PROPOSED IMPROVEMENT
BRIDGE PROJECT
TOWN OF RICHFORD
COUNTY OF FRANKLIN
BRIDGE NO.41 ON TOWN HIGHWAY NO.2

RECORD PLANS	
CONTRACTOR	BLOW & COTE - MORRISVILLE, VT
RESIDENT ENGINEER	CARL GLEASON
CONSTRUCTION BEGAN	MARCH 7, 2008
CONSTRUCTION COMPLETE	MAY 5, 2009
RECORD PLANS BY	CARL GLEASON

DIRECTOR OF PROGRAM DEVELOPMENT	
APPROVED <i>Richard Tripp</i>	DATE <i>12/16/11</i>
PROJECT MANAGER : WARREN TRIPP	
PROJECT NAME : RICHFORD	
PROJECT NUMBER : BHF 0302 (3) S	
SHEET 1 OF 41 SHEETS

PROJECT NAME:	RICHFORD	FILE NAME:	...Design\Rich-steeldets2.dgn	PLOT DATE:	12/18/2007
PROJECT NUMBER:	BHF 0302 (3) S	PROJECT LEADER:	MJC	DRAWN BY:	JJS
		DESIGNED BY:	SEB	CHECKED BY:	MJC
		STEEL DETAILS SHEET 2		SHEET	24 OF 41

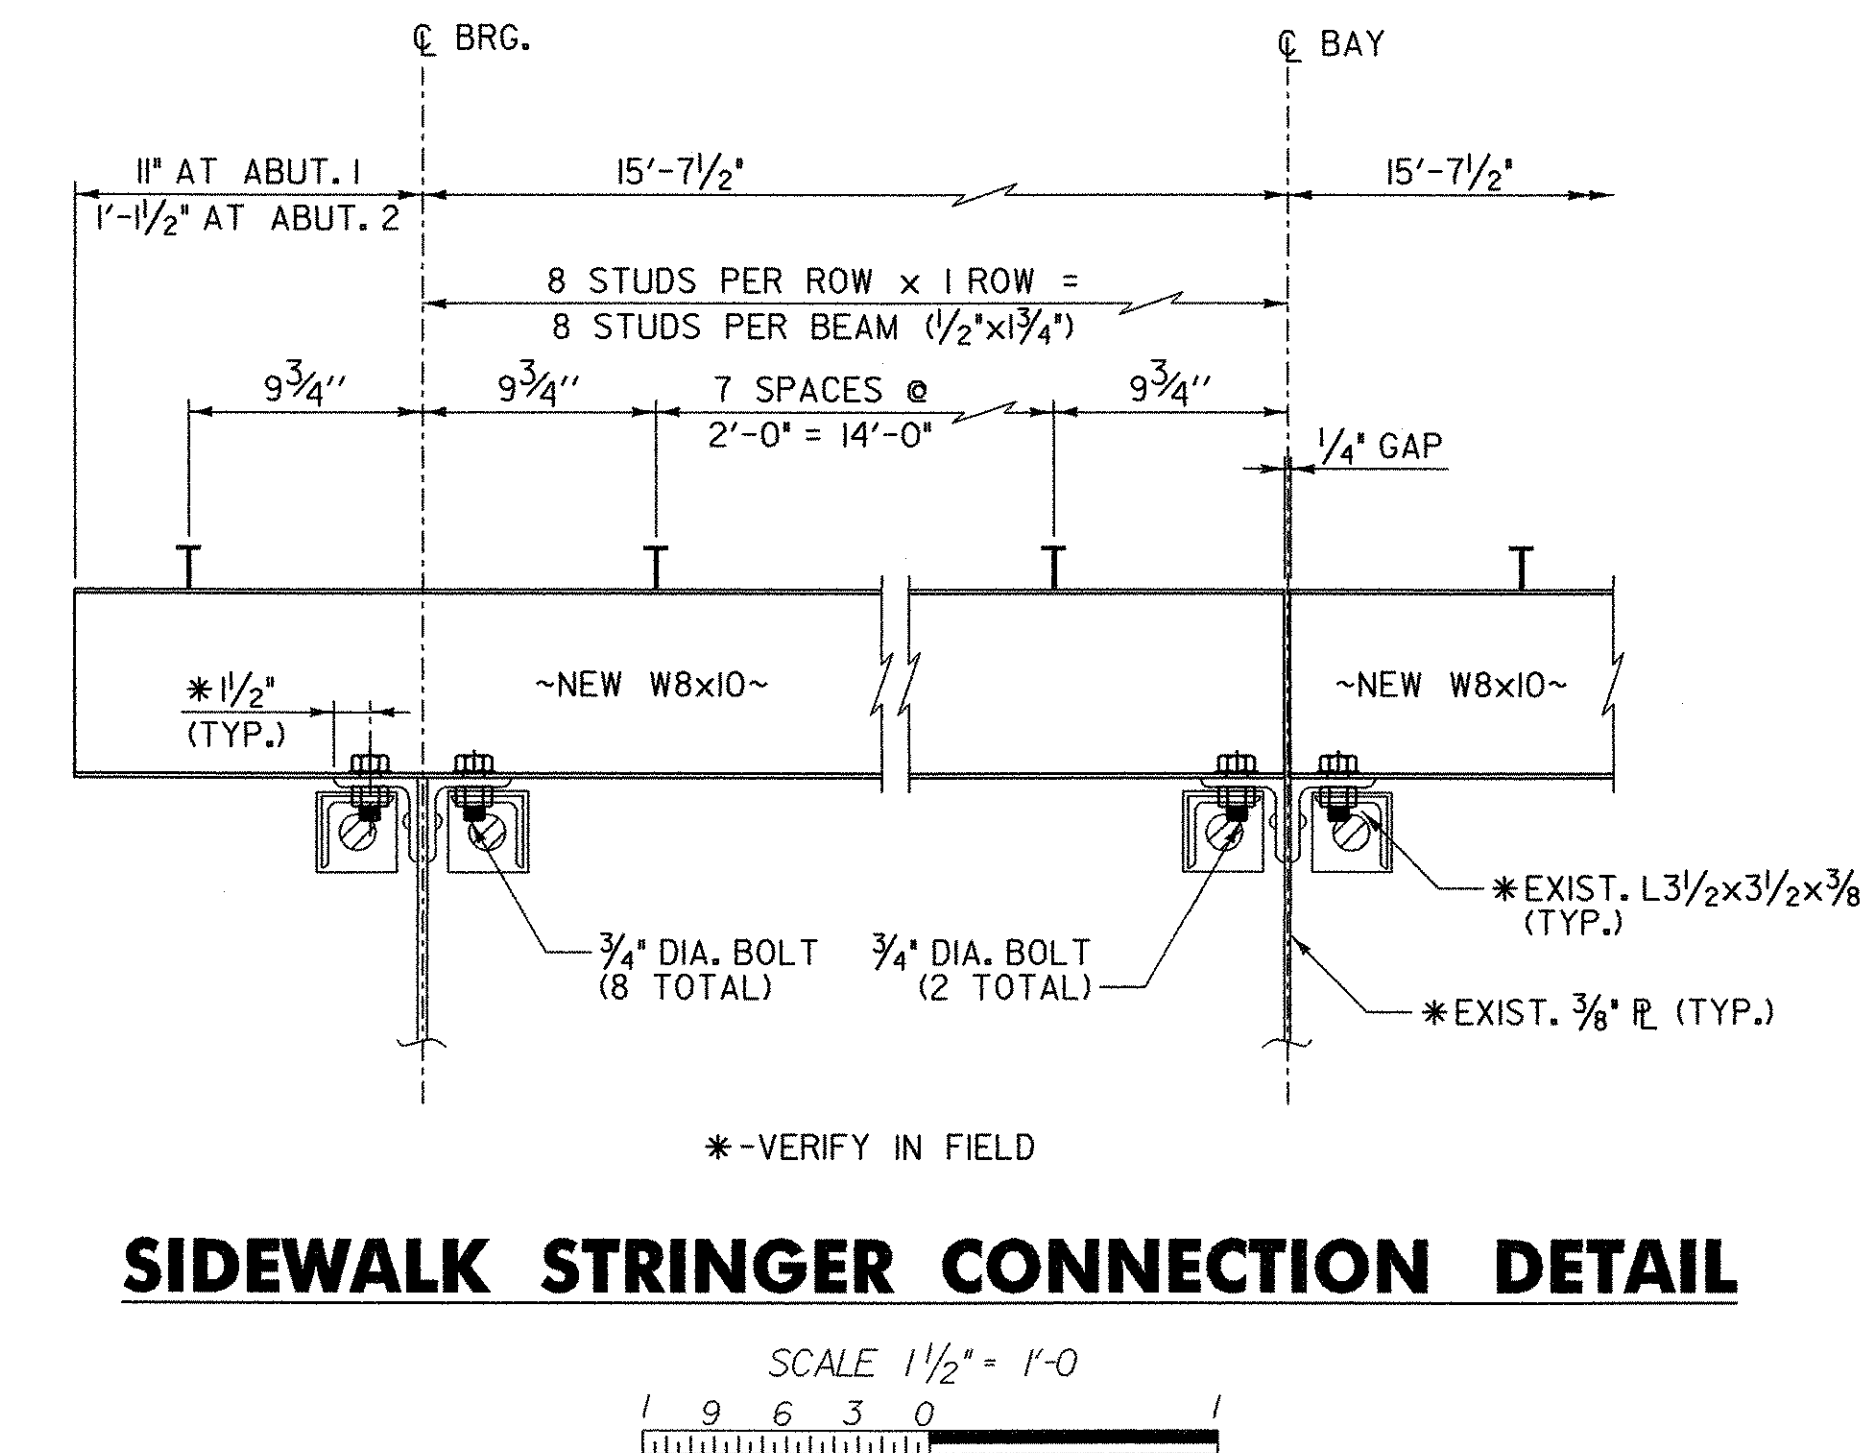
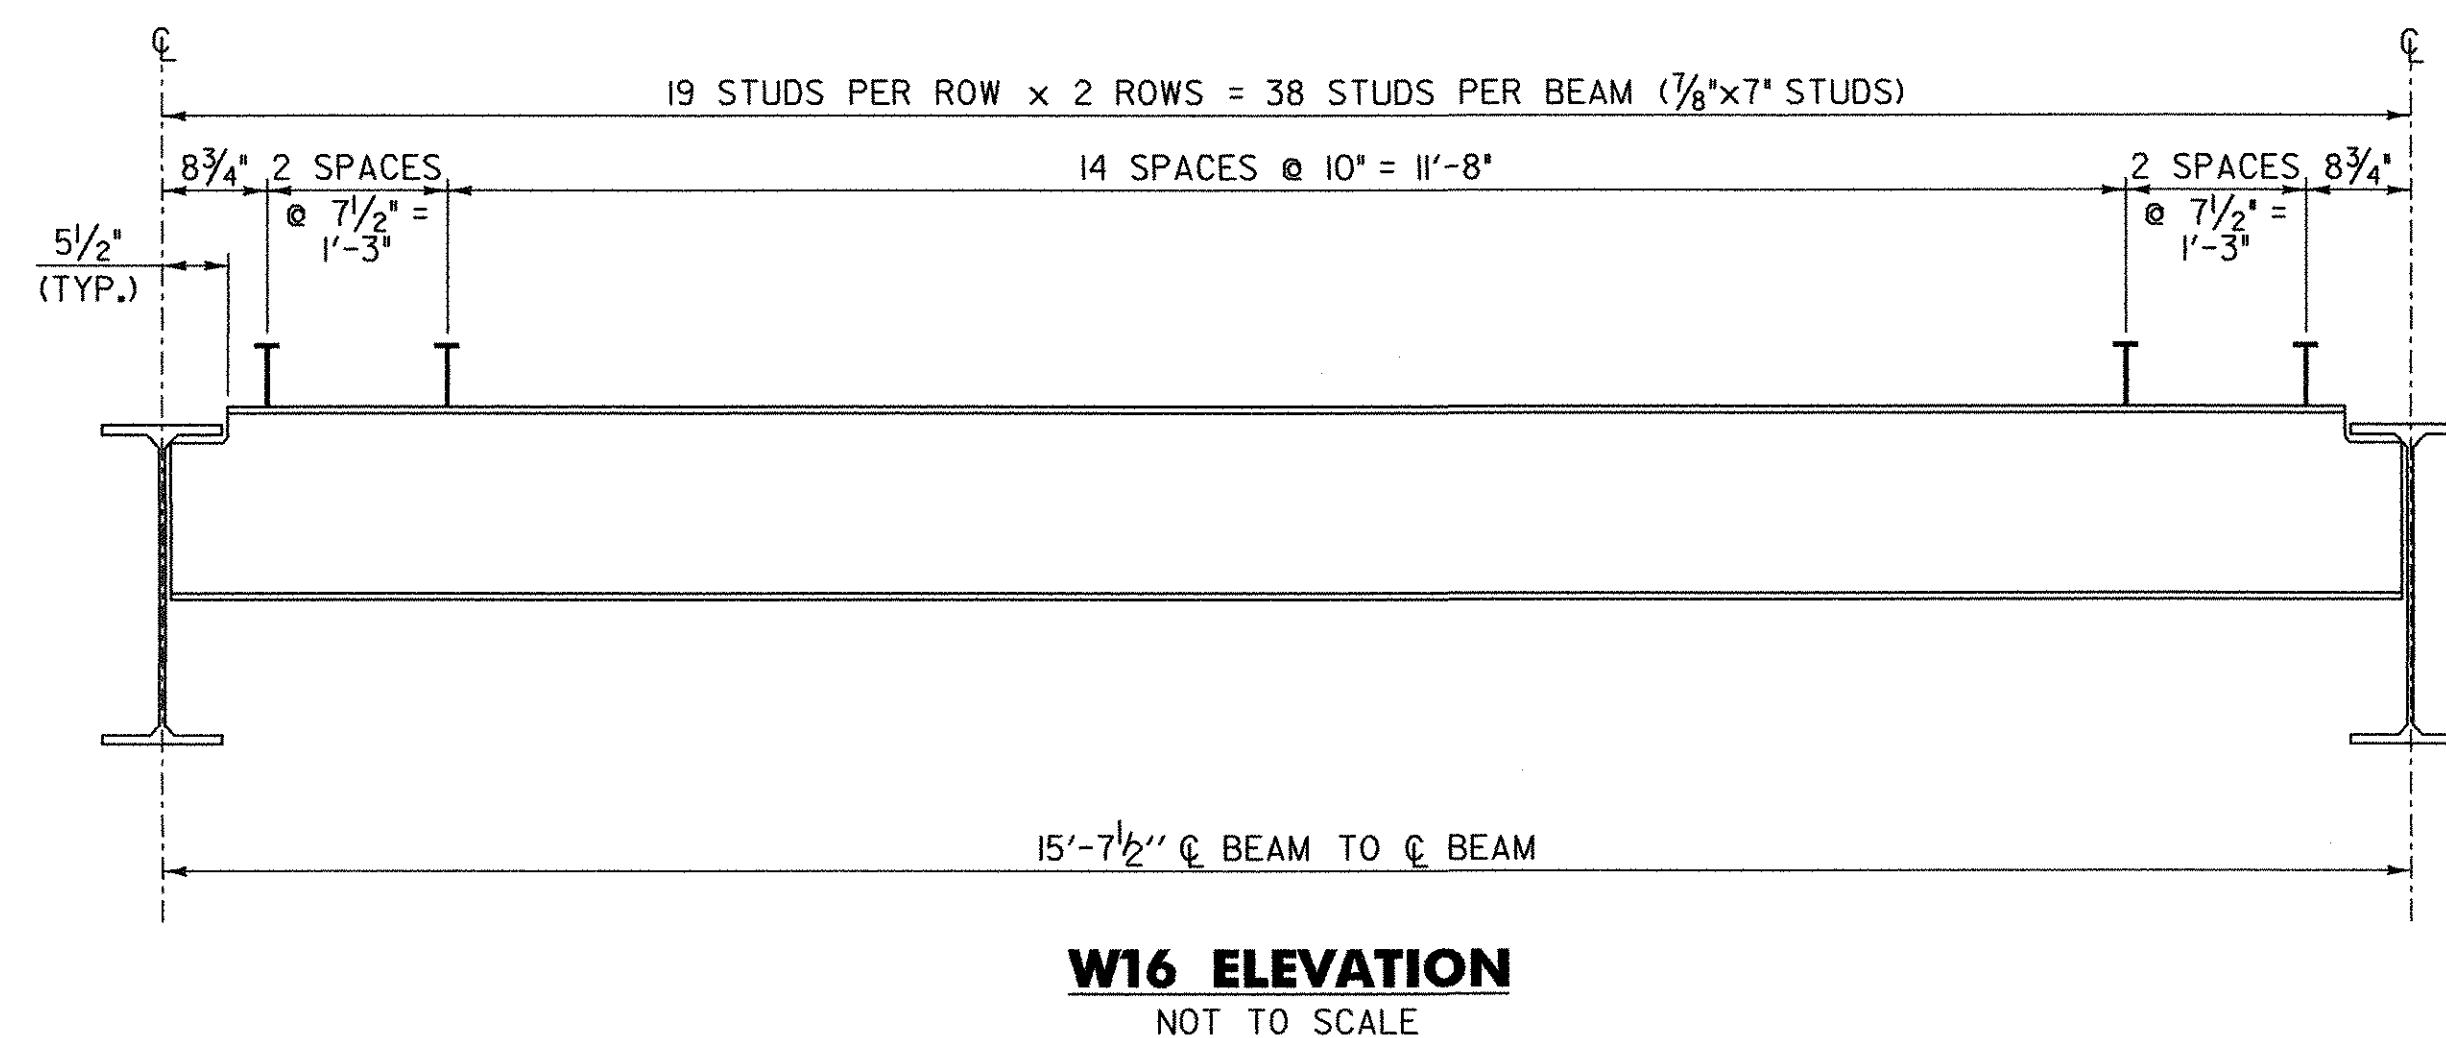
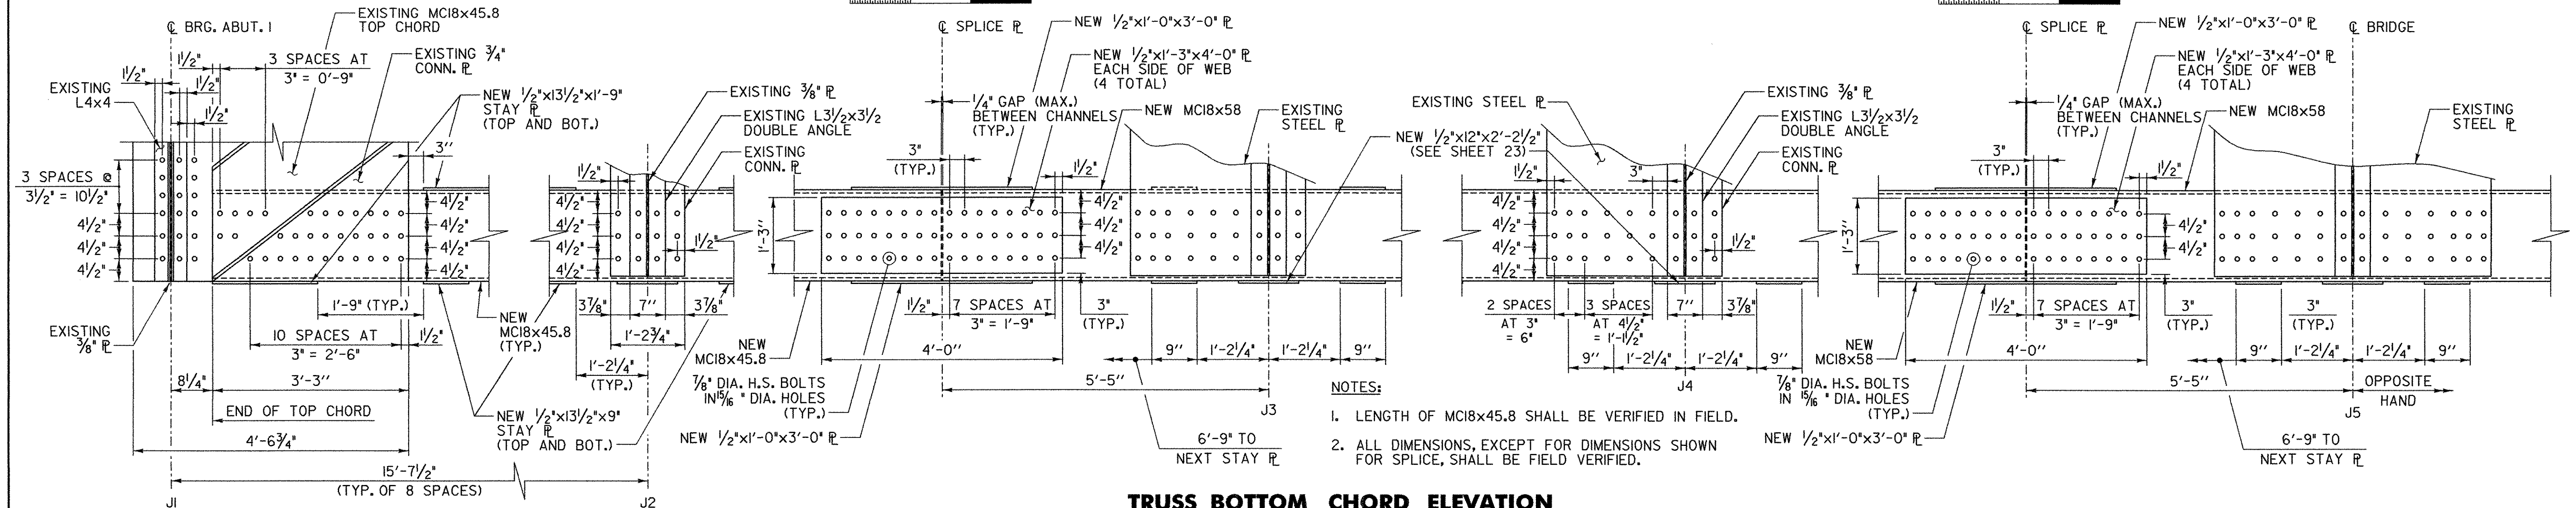
As noted at the end of the following e-mail, will you please confirm or correct the number of stay plates needed, based on the number on the existing trusses? As soon as we are in agreement, I will forward the information to Casco Bay so that the shop drawings can be revised. Thanks.

Piece Marks T11, T12, T81, and T82 (Left & Right) - Add an additional intermediate stay plate top and bottom between the top end stay plate and the first intermediate plate stay plates (top & bottom) at 10'-0". Add an additional stay plate top and bottom between the intermediate stay plate located at 19'-4 1/2" and the splice. Please note that this missing intermediate stay plate is located at a clear distance of 6'-9" from the intermediate stay plate located 1'-2 1/4" from the truss joint. These dimensions are shown on the Truss Bottom Chord Elevation, located on sheet 24 of the contract drawings.

Piece Marks T31, T32, T61 and T62 (Left & Right) - Add an additional intermediate stay plate top and bottom between the intermediate stay plate located at 26'-1" (please verify this location, it is greater than 3.125 feet from the stay plate at 22'-4 1/8") and the splice. This missing intermediate stay plate is also located 6'-9" from the intermediate stay plate between the splice and the joint.

Piece marks T51 and T52 have the correct number of intermediate stay plates.

Adding these stay plates will provide three top and four bottom intermediate stay plates in bays 1 and 8. There will now be four intermediate stay plates top and bottom in bays 2 and 7. And four intermediate stay plates in bays 4 and 5. Bays 3 and 6 will still have 5 intermediate stay plates as shown on the shop drawings.

Warren could you please ask the resident to verify if the number of intermediate stay plates on the existing trusses matches the numbers above.
